**ON-SITE SEWAGE DISPOSAL SYSTEM
HOWARD COUNTY HEALTH DEPARTMENT
BUREAU OF ENVIRONMENTAL HEALTH**

SUBDIVISION: Paddocks East LOT NUMBER: 10

ADDRESS: 13557 Julia Manor PROPERTY OWNER: Pulte Homes, Inc.

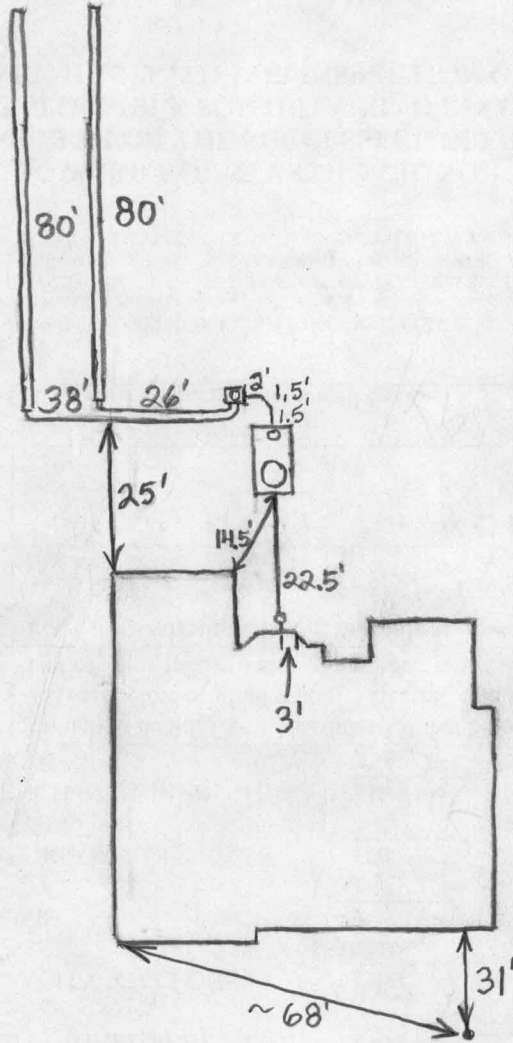
LINEAR FEET OF TRENCH REQUIRED: 126 ^{OK} HOUSE SERVED BY PUBLIC WATER
160' → 2-80' Trenches

*Inlet 3'
Bottom 8'
Trenches 2' Wide*

TRENCHES:	Trench to be 3.0 feet wide. Inlet 3.0 feet below original grade. Bottom maximum depth 7.0 feet below original grade. Effective area begins at 3.0 feet below original grade. 4.0 feet of stone below distribution pipe.
LOCATION:	Place the distribution box in the highest elevation of the approved SDA. <u>5/27/05</u> <i>Specs changed to maximize use of</i>
NOTES:	<i>area near driveway. (BB)</i>

TRENCH/DRAINFIELD DATA

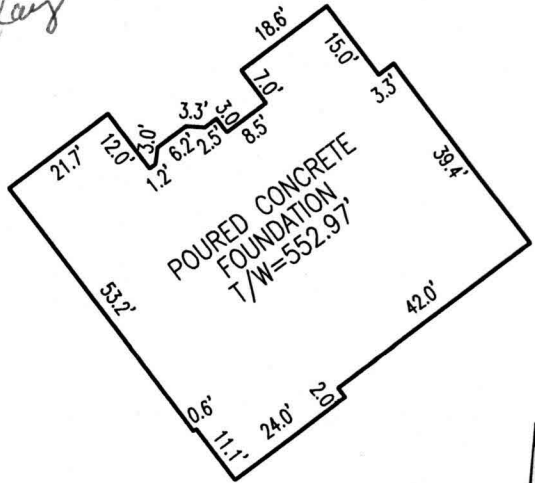
155' = Same Amount Stone as 126'

PRE-CONSTRUCTION 5/27/05 To install 2 - 80' trenches with revised specs. across top of easement near driveway so as to avoid any future conflicts with driveway. Installation as to avoid any future conflicts with driveway. Trenches will be off contour slightly. Tank set and house connection made (BB) 5/31/05 System installed and looks O.K. Alright to cover everything. (BB)
